Submissions Report

Monaro Rock Quarry

Development Application No. SSD- 27223807

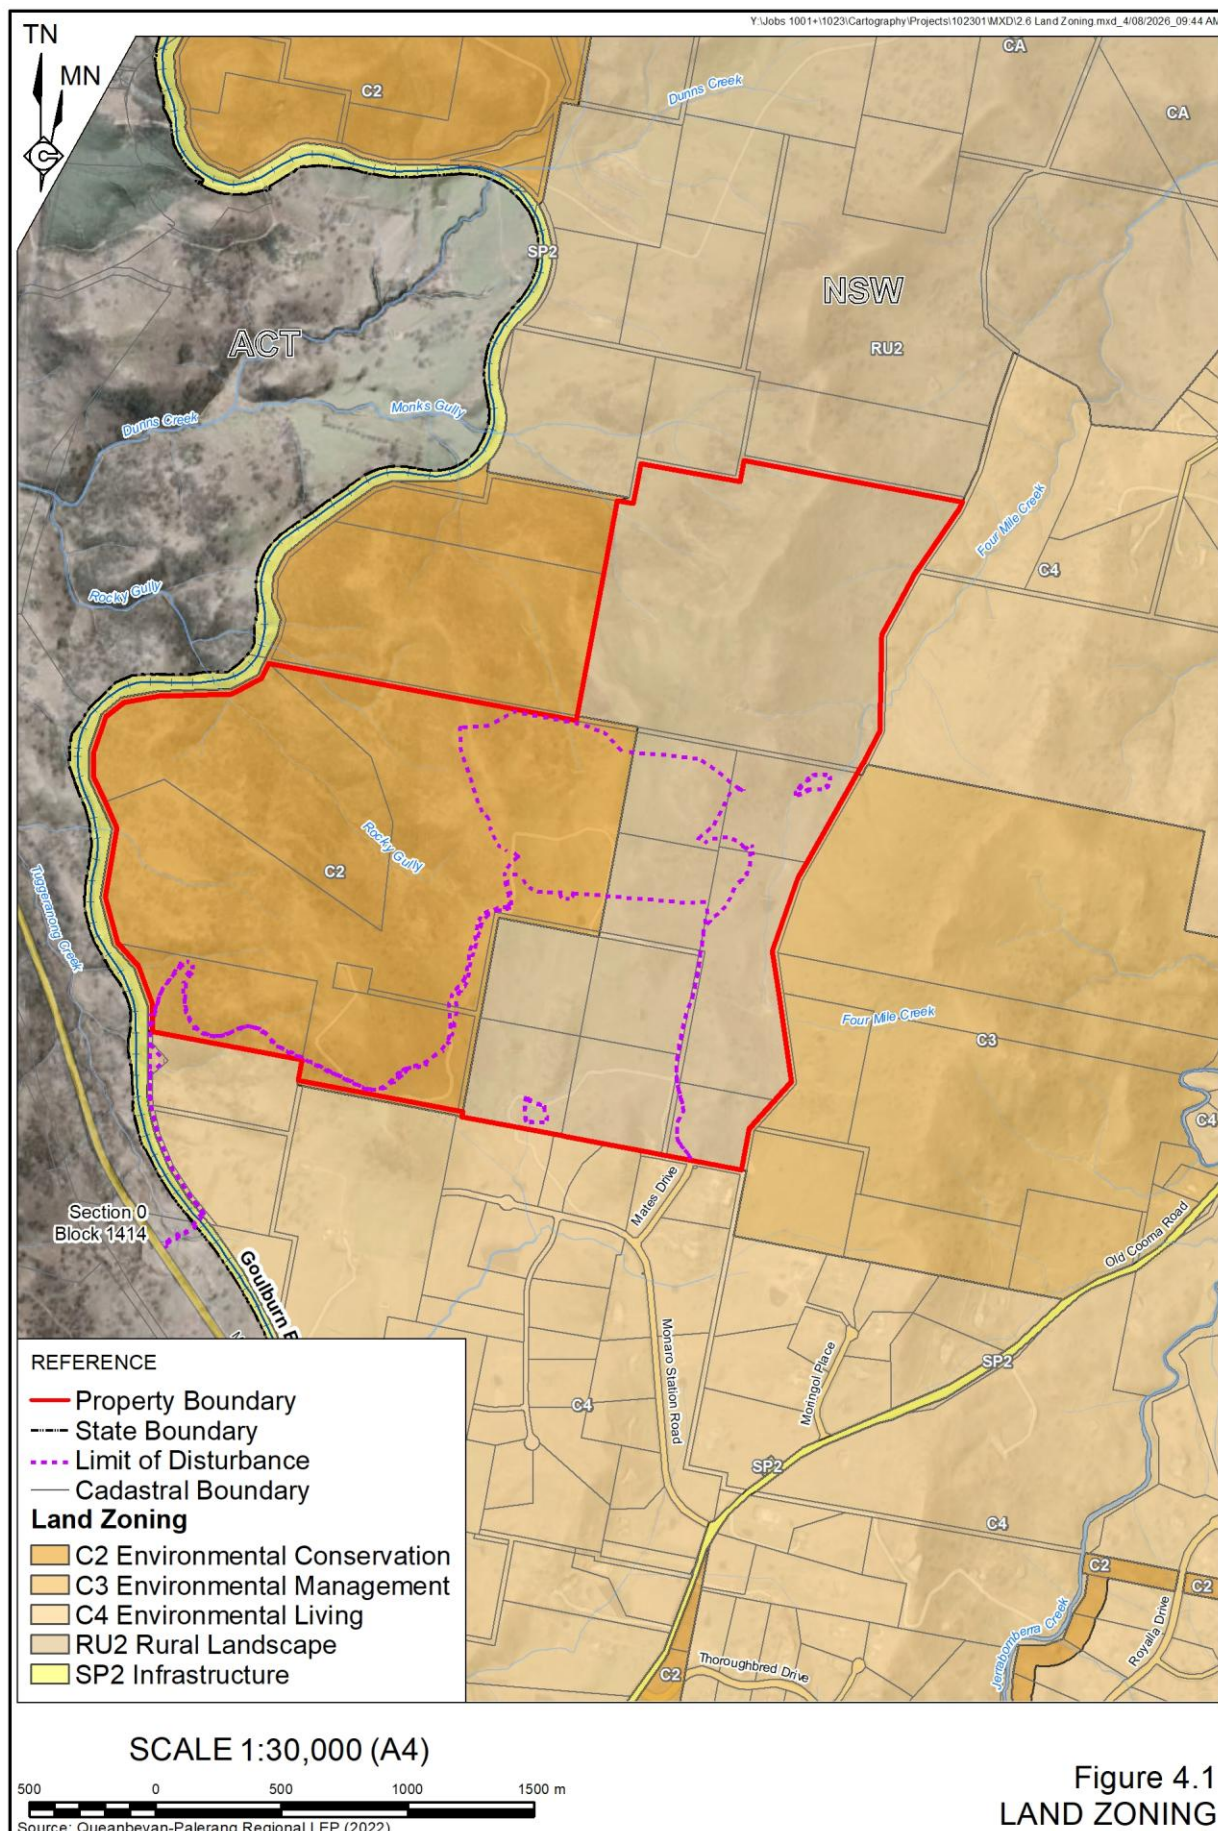
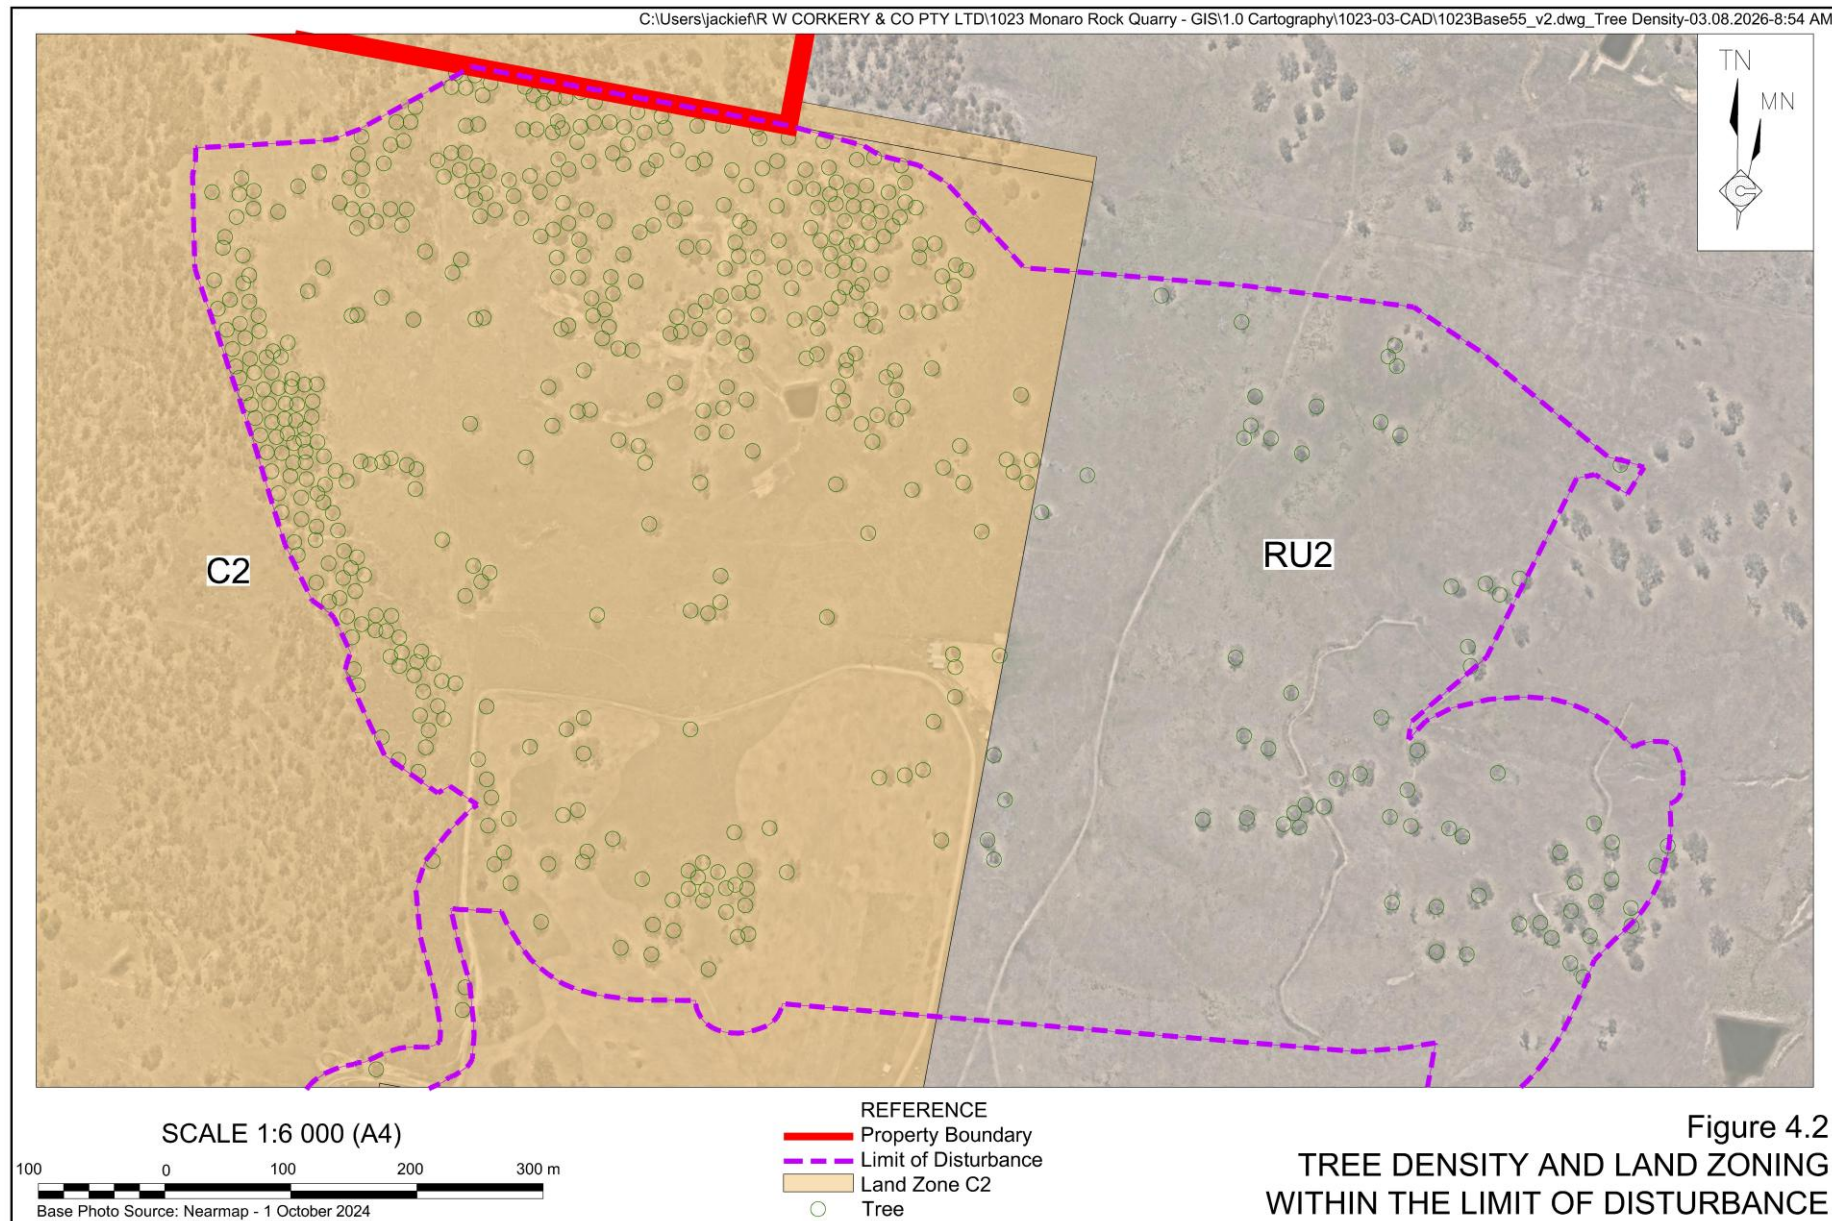
- To protect, manage and restore areas of high ecological, scientific, cultural or aesthetic values.*
- To prevent development that could destroy, damage or otherwise have an adverse effect on those values.*
- To encourage rehabilitation and regeneration of ecosystems.*
- To provide for a limited range of development and land use activities that support environmental conservation outcomes.*
- To identify and protect escarpment areas that enhance the visual amenity of Queanbeyan-Palerang Regional local government area and possess special aesthetic or conservational value.*
- To protect water quality by preventing inappropriate development within catchment areas.*

Figure 4.1 displays the land zoning within the local area and **Figure 4.2** presents the zoning of the Project Site including a tree density analysis. The Project would be developed on land that is partially zoned Rural Landscape (RU2) and partially zoned Environmental Conservation (C2) as described in the *Queanbeyan-Palerang Local Environmental Plan 2022* (LEP). The Quarry Access Road would cross the railway corridor and land zoned Infrastructure (SP2). Surrounding the property, land is zoned Rural Landscape (RU2), Environmental Conservation (C2), Environmental Management (C3), and Environmental Living (C4).
